Application Number: LU/14855(TP55/2022)

APPLICATION FOR TEMPORARY DEPARTURE ON FARM 153, STELLENBOSCH DIVISION (KYLEMORE)

MEMORANDUM

CONCEPT SERVICES LAYOUT

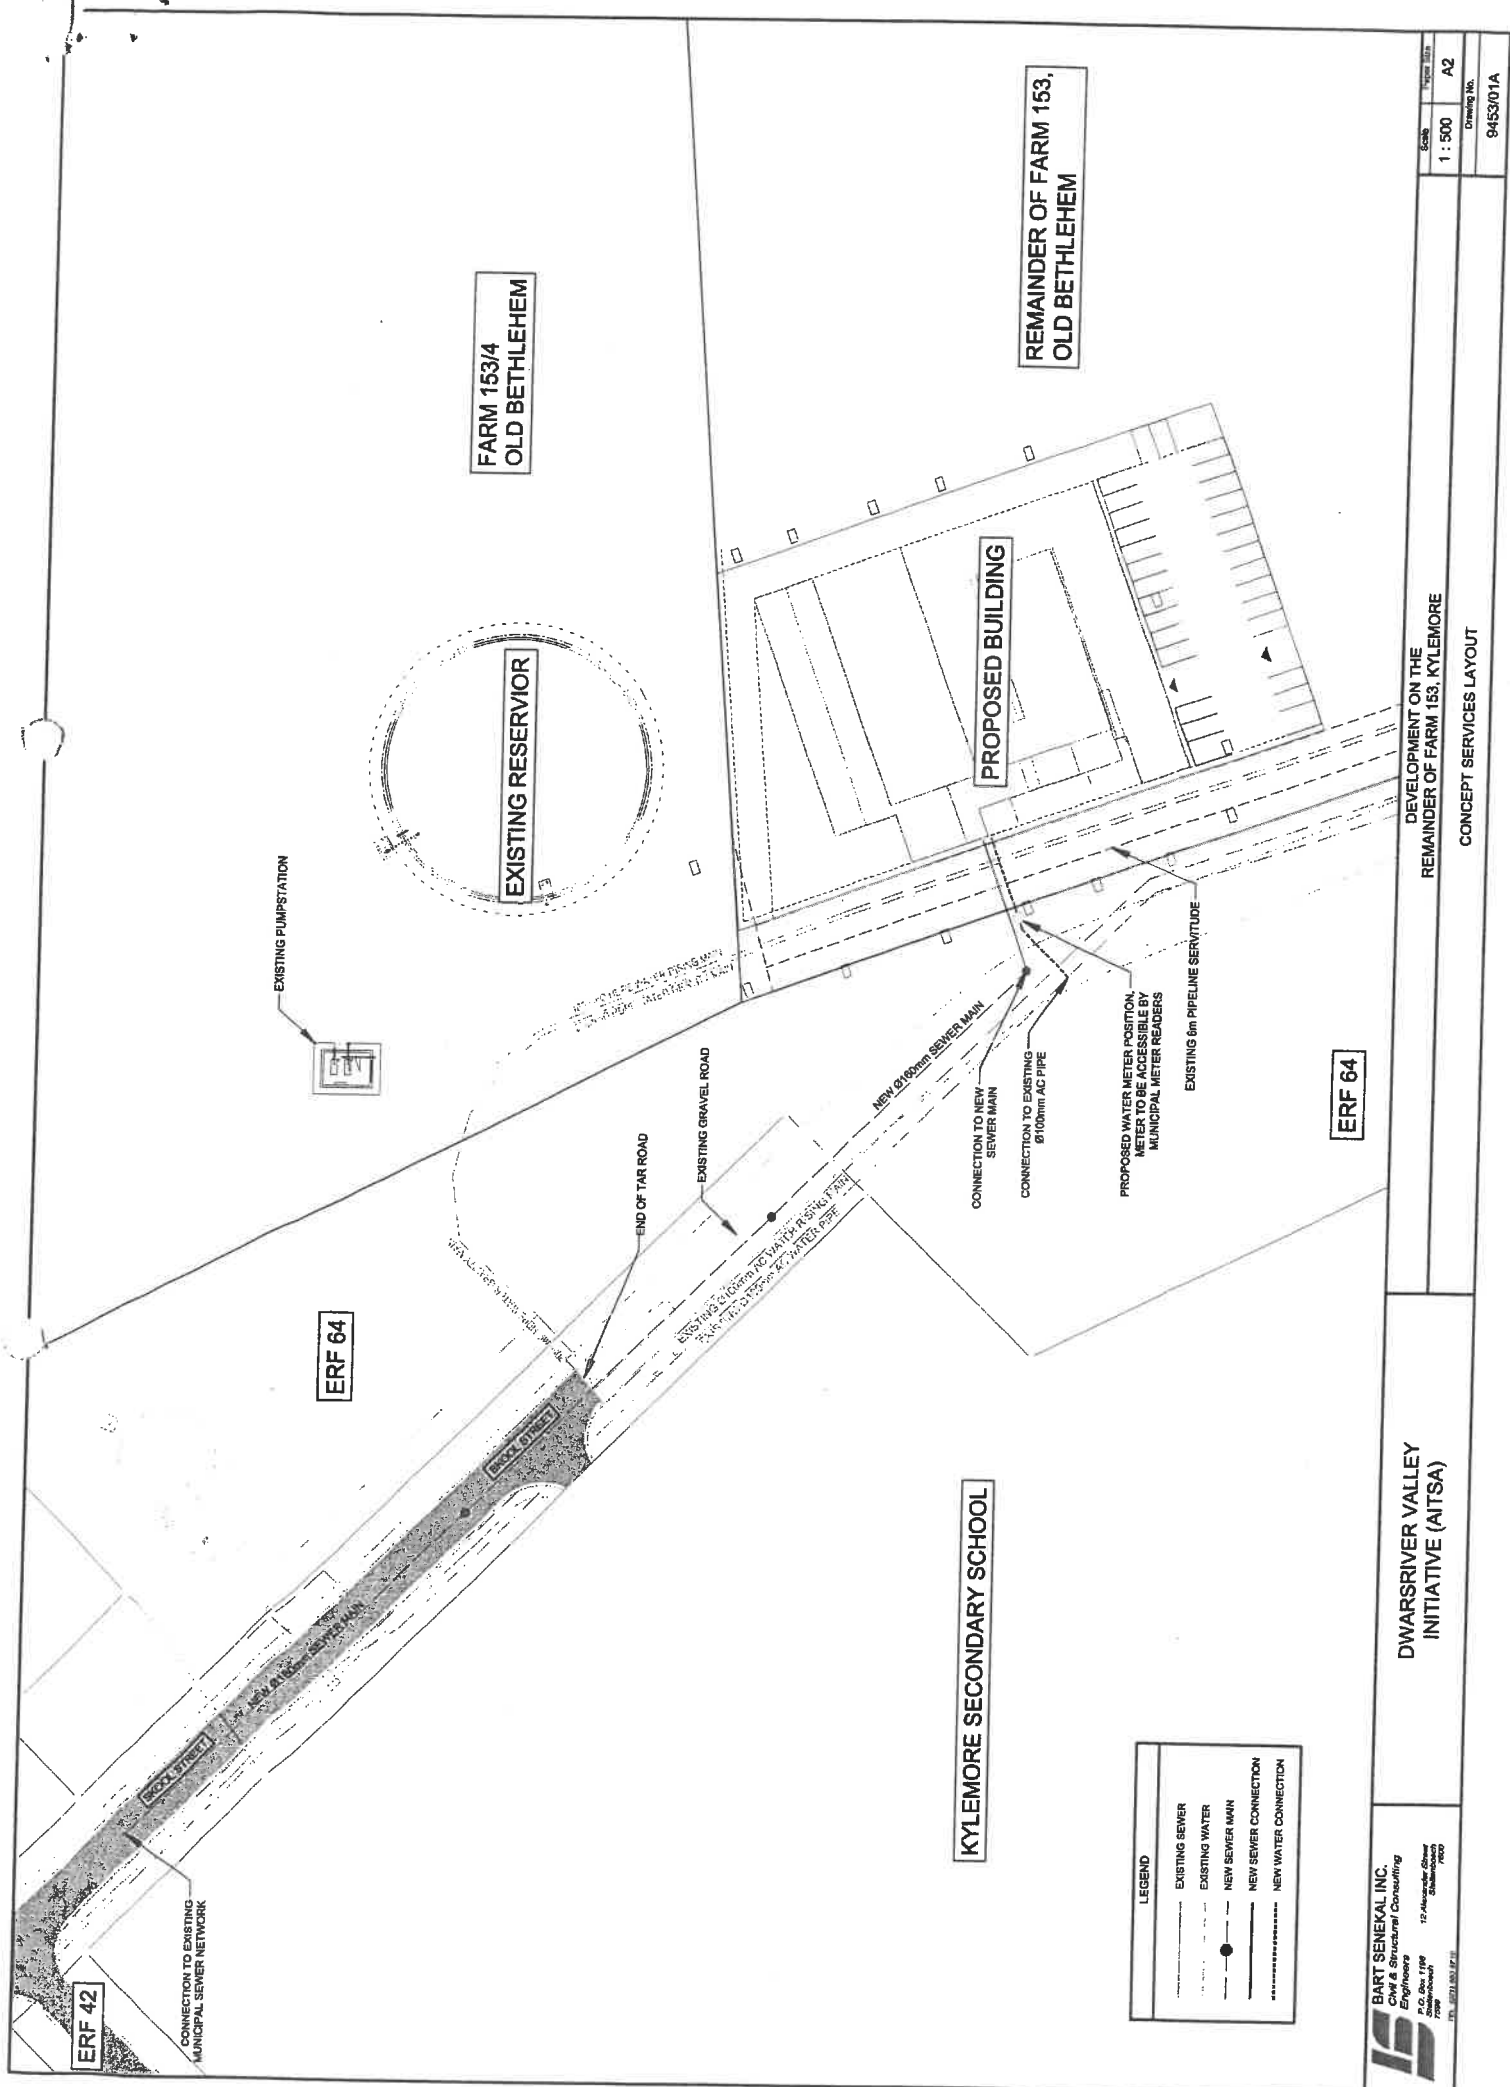
- 1.1 The provision of services must be generally in accordance with the Concept Services Layout Drawing No 9453/01A by Bart Senekal (attached).
- 1.2 Detail engineering drawings must be submitted concurrent with the building plans. Such drawings must clearly indicate all civil engineering elements including
 - 1.2.1 access roads
 - 1.2.2 access point details
 - 1.2.3 parking
 - 1.2.4 water
 - 1.2.5 sewer

1.2.9 the positioning of the structures must take existing services into account.

1.2.10 It is further recommended that the school not be constructed on the edge of the servitude, as any maintenance or upgrade work on the pipelines in the future could lead to disturbances, inconveniences and safety hazards to the school and pupils.
